## Response to Referee #1

**[Comment 1]** The paper “Integration of the Vegetation Phenology Module Improves Ecohydrological Simulation by the SWAT-Carbon Model” modifies the SWAT-Carbon model to include a process-based method for estimating the start and end of the growing season based on parameterizations of environmental conditions. The paper is logically structured and provides an interesting and relevant analysis. The introduction provides a nice overview of previous research and sets up the study very nicely. The data and methods section describes the details of the experiment very well and is easy to understand. The results present an interesting analysis that compares the two model runs.

**Figure S1: Temporal variability of the LAI during the calibration (2007–2011) and validation (2012–2014) periods.** 8-d LAI time series observed by satellite and simulated by the original SWAT-Carbon model with adjusting non-growing season LAI for Forest (a) and grassland (b).

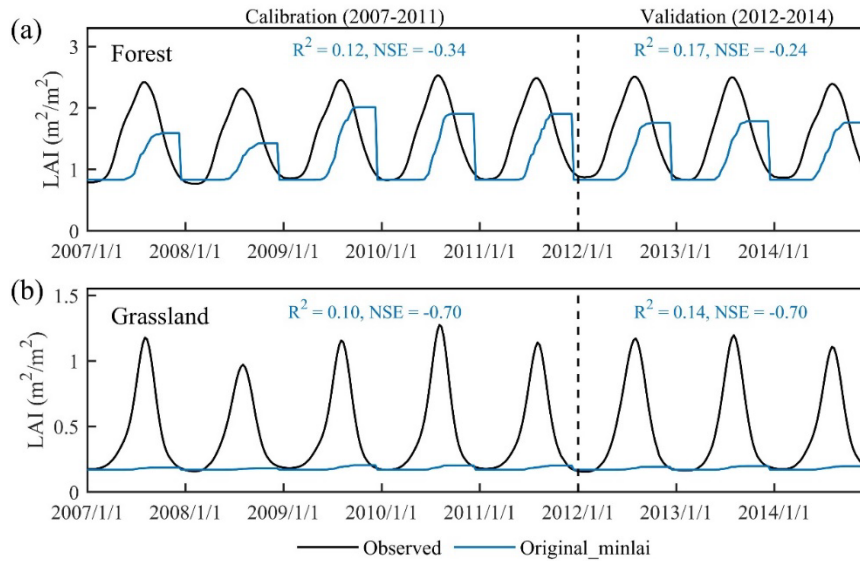
**[Comment 5]** Line 218 – Changing the none growing season LAI to a non-zero value greatly improved the statistics, but this should have been done for the original model too to make it a fair comparison. As is, the statistical improvement between the original and the modified is mostly due to this arbitrary choice of changing the none growing season LAI to a non-zero value and does not capture the improvement in the model's ability to estimate SOS and EOS. The improvement from the two different changes in the modified model should be carefully analyzed and discussed.

**[Response 5]** We thank the referee for this thoughtful comment. Following the referee's suggestion, we revised the non-growing season LAI in the original SWAT-Carbon model by adjusting the default management operation schedule and values of minimum LAI parameters (ALAI\_MIN). We found that compared to the default settings, there are only slight improvements in the LAI growth curves of the original model (Figure S1). Specifically, the average NSE value improved from -1.42 to -0.29 for forests and from -1.84 to -0.70 for grasslands, which is much smaller than NSE for LAI in the modified model (0.78 for forest and 0.87 for grassland). Furthermore, we even found that the average  $R^2$  decreased by 0.17 for forests and by 0.01 for grasslands, respectively. These results demonstrated the importance of incorporating the phenological module into SWAT-Carbon model.

In the revised manuscript, we included these findings in the supplementary figure S1, along with additional descriptions of results and corresponding discussions:

*“To further exclude the impact of non-growing season LAI, we also changed the non-growing season LAI to non-zero in the original SWAT-Carbon model. The results indicated that, compared to the default settings, there are only slight improvements in the LAI growth curves in the original model (Figure S1). Specifically, the average NSE value improved from -1.42 to -0.29 for forests and from -1.84 to -0.70 for grasslands, which is much smaller than NSE for LAI in the modified model. Furthermore, the average  $R^2$  even decreased by 0.17 for forests and by 0.01 for grasslands, respectively.”*

**Figure 7: Relationship between the phenological variations and sub-basin scales evapotranspiration (ET) using modified SWAT-Carbon model.** GSL, growing season length; SOS, start-of-season; EOS, end-of-season; ET, evapotranspiration.

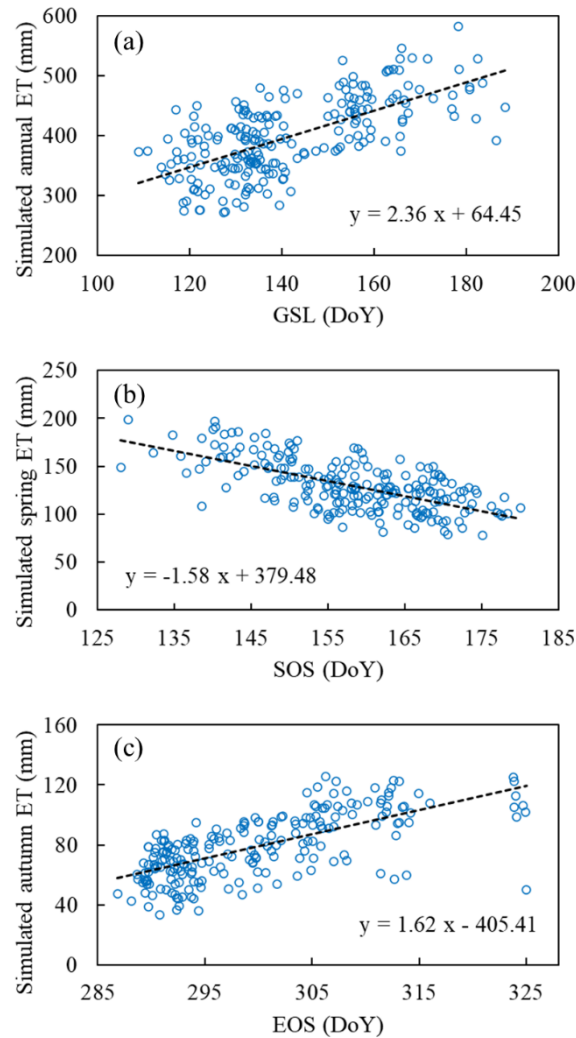
**[Comment 8]** Line 275: This discussion section also needs revisions. When does the analysis show “a positive correlation between ET and growing season length”? If the figures in supplementary material are so important that they are worth discussing in the discussion section, then they should probably be included in the paper

**[Response 8]** We thank the referee for this comment. Following referee’s suggestion, we incorporated the figure S2 into the section 4.2 of the paper and updated the corresponding text in the revised manuscript:

*“In addition, the vegetation dynamics and its impact on the underlying land surface properties affect watershed evapotranspiration (Chen et al., 2022b). To explore the response of ET to vegetation phenology in the upper reach of Jinsha River watershed, we analyzed the relationship between the phenological variations and sub-basin scales ET using modified SWAT-Carbon model. Consistent with previous studies in the Northern Hemisphere, our study revealed a positive correlation between ET and growing season length (Figure 7), potentially attributed to the prolonged period of water movement from the soil to the atmosphere (Geng et al., 2020; Yang et al., 2023).”*
